## Model Error Resolution Document

1. Originator: John Case/Ernest Hardin	2. Date: 07/11/2008	3. ERD No. ANL-NBS-HS-000057 ERD 02
---	------------------------	--

4. Document Identifier: ANL-NBS-HS-000057 REV 00	5. Document Title: Postclosure Analysis of the Range of Design Thermal Loadings
---	--

Corrections and clarifications to ANL-NBS-HS-000057 REV 00 are made in response to CR-12172. A justification for no impact to results of the subject AMR, and for other products that use output from this report as direct input, is also included.

Figure 6.2-13 Mid-Pillar Temperature for a Line-Source Solution, Using the Postclosure Reference Thermal Load and Varying Host-Rock Thermal Conductivity

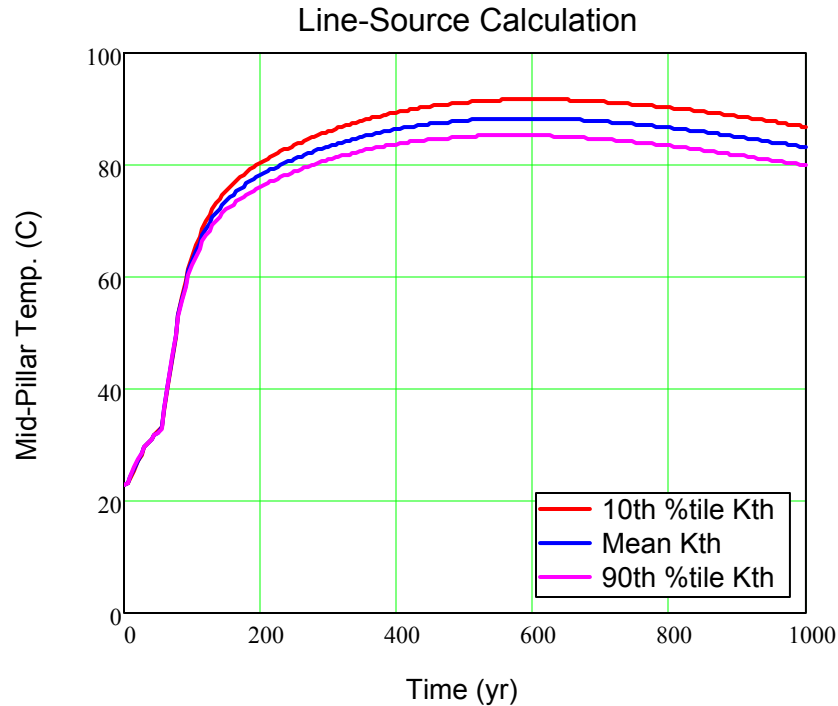
**II.2** (Fig. 6.2-13 and output DTN MO0705SUPPCALC.000). This figure is reasonable but cannot be traced to the Mathcad file indicated as the source. A revised Mathcad file is provided (filename: *WPIMP vs. Kth (corrected) August 2008.xmcd*) containing a traceable plot for 50-yr ventilation, 86% efficiency, host rock saturation 100%, and neglecting the effect of lithophysal porosity on the (volumetric) heat capacitance. The DTN is revised to include the corrected file.

Figure 6.2-13 and its accompanying notes are revised as follows:

Source: Output DTN: MO0705SUPPCALC.000, Directory: Other Supporting Files, File: *WPIMP vs. Kth (corrected) August 2008.xmcd*.

NOTES: The 10<sup>th</sup> percentile, mean, and 90<sup>th</sup> percentile values for wet thermal conductivity of the lower lithophysal (Tptpl) host unit are 1.69, 1.87, and 2.06 W/m-K, respectively. Calculated using a ventilation duration of 50 years, preclosure ventilation heat removal efficiency of 86%, and neglecting the effect from lithophysal porosity on heat capacitance.
